ADDENDUM NO. 1
JANUARY 11, 2019
ERIE INTERNATIONAL AIRPORT
TERMINAL FLOORING REPLACEMENT

**ADDENDUM
ADDENDUM NO. 1
January 11, 2019**

EXHIBIT "A"
ERRA FLOORING SCOPE
DIAGRAM

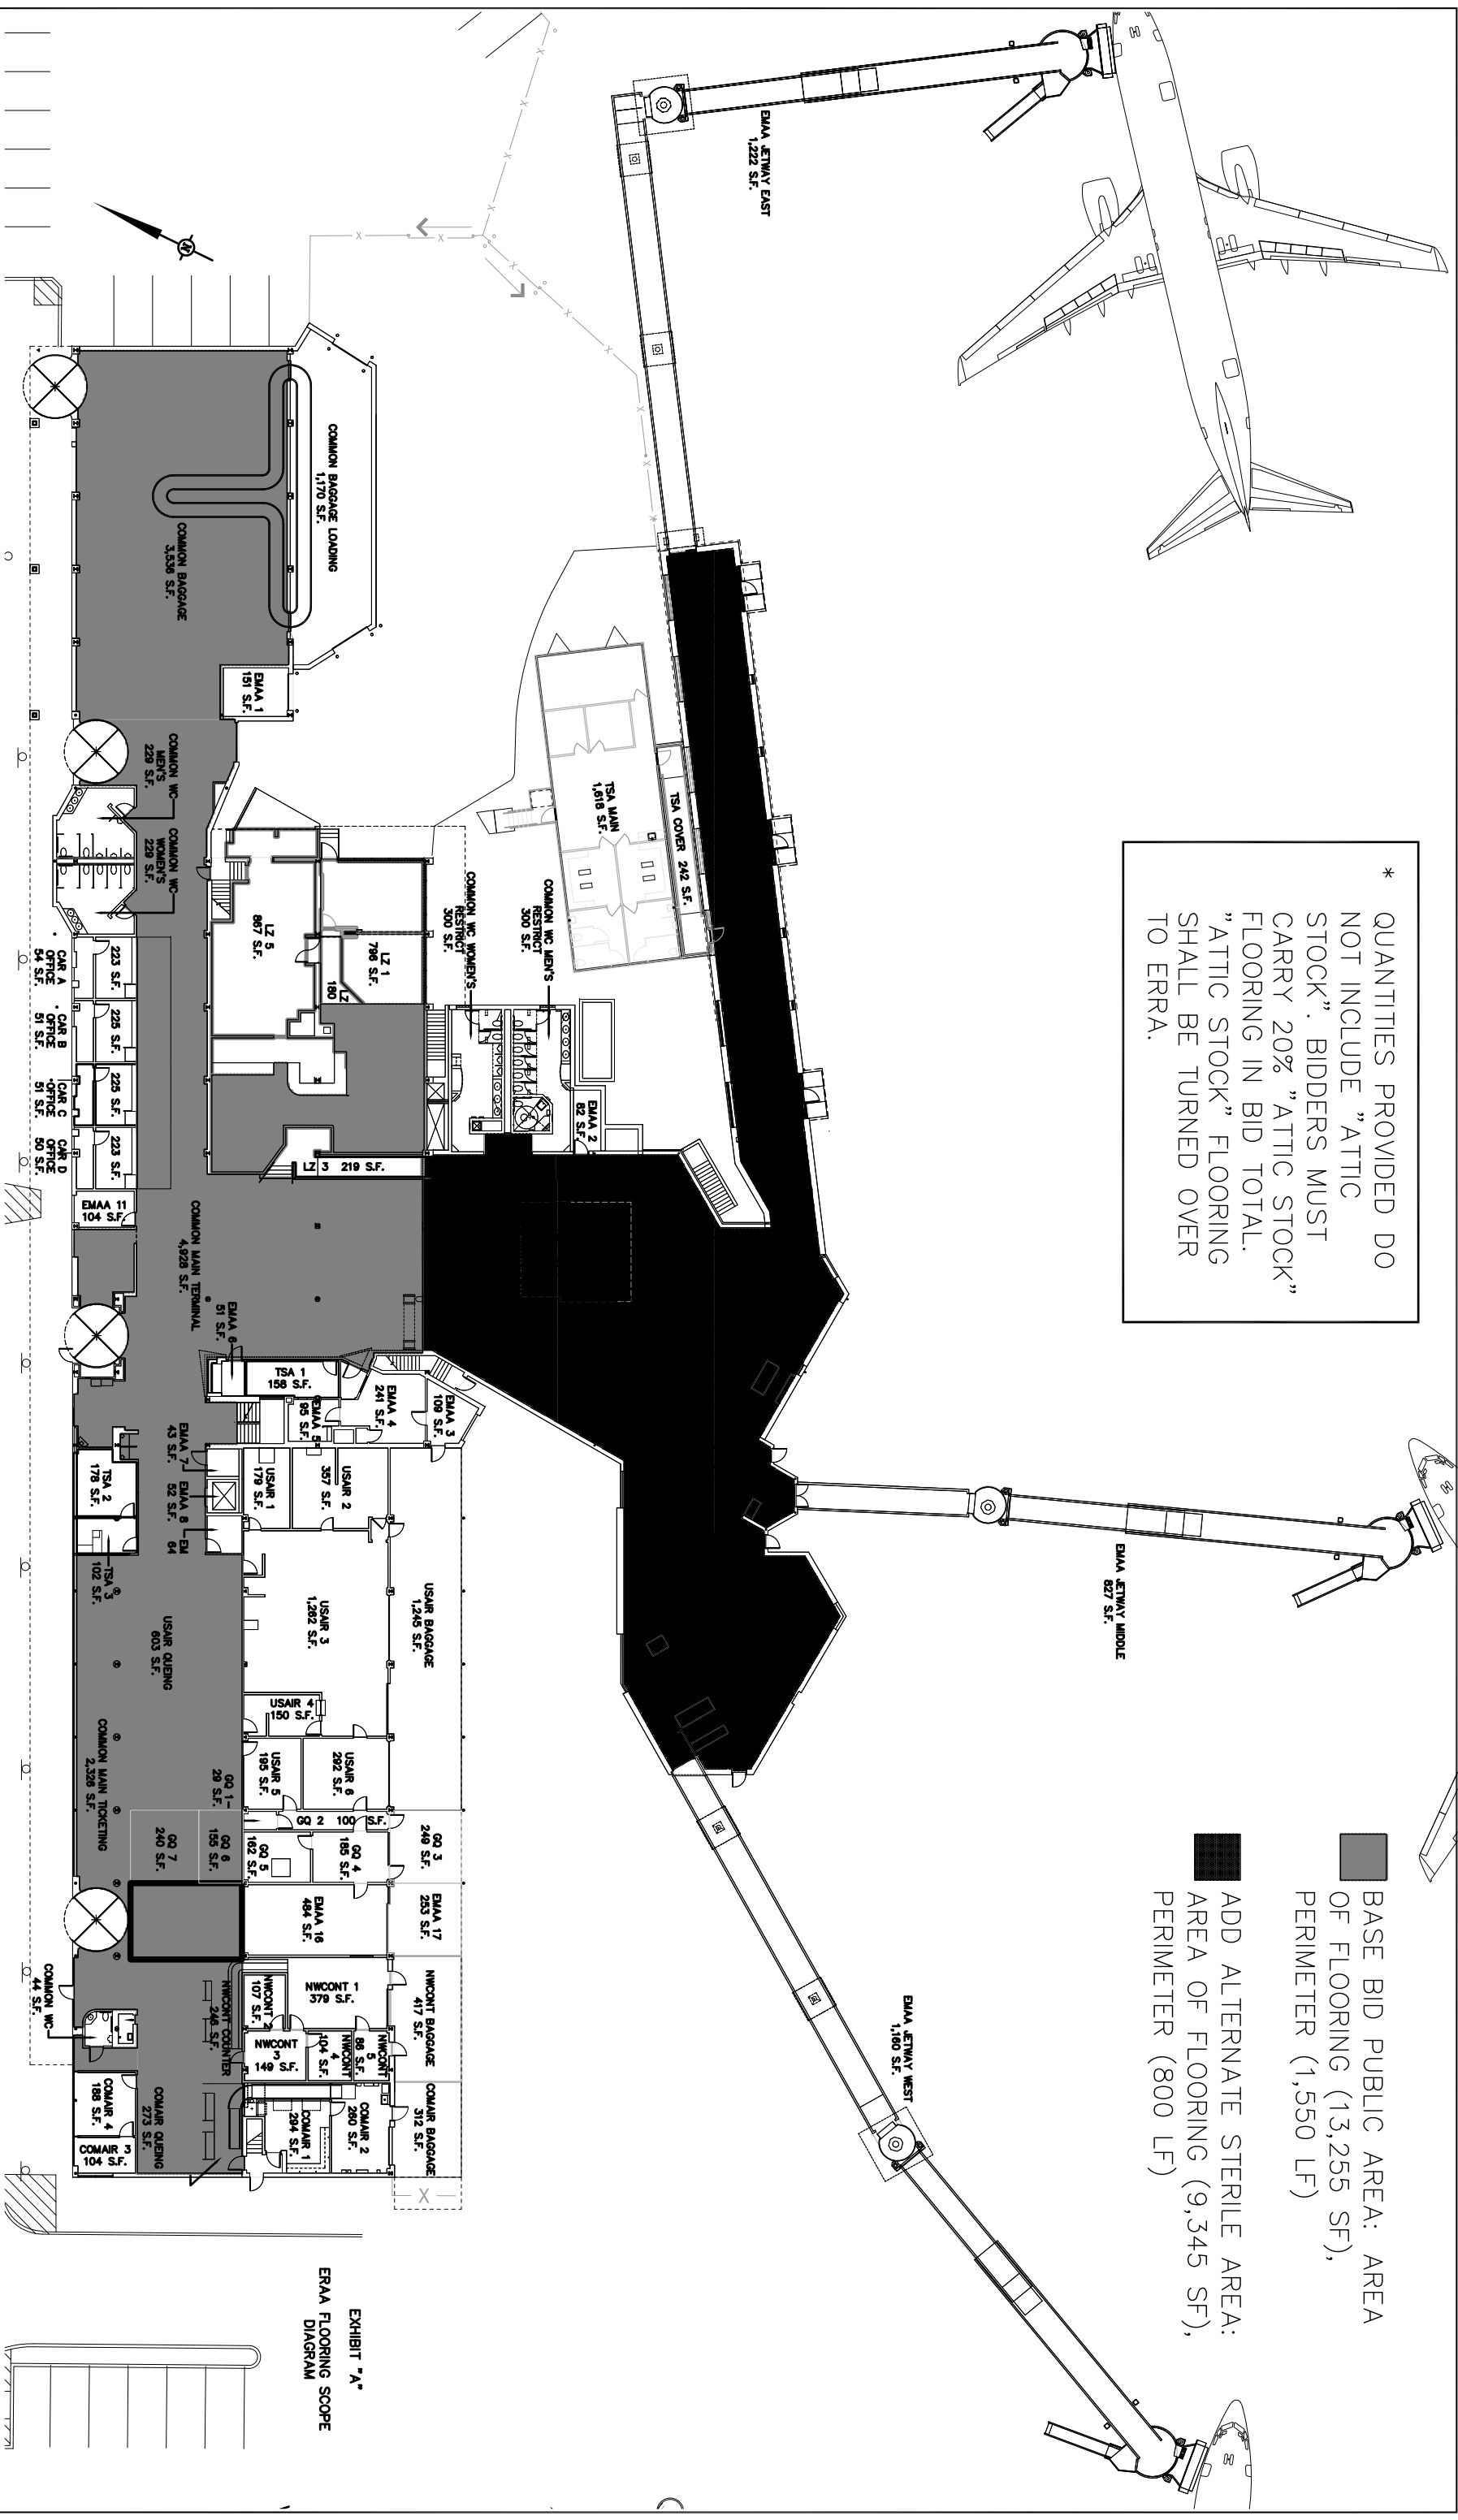
1. Delete Exhibit A and replace with the attached Exhibit A, REV 1.

* QUANTITIES PROVIDED DO NOT INCLUDE "ATTIC STOCK". BIDDERS MUST CARRY 20% "ATTIC STOCK" FLOORING IN BID TOTAL. "ATTIC STOCK" FLOORING SHALL BE TURNED OVER TO ERRA.

■ BASE BID PUBLIC AREA: AREA OF FLOORING (13,255 SF), PERIMETER (1,550 LF)
 ■ ADD ALTERNATE STERILE AREA: AREA OF FLOORING (9,345 SF), PERIMETER (800 LF)
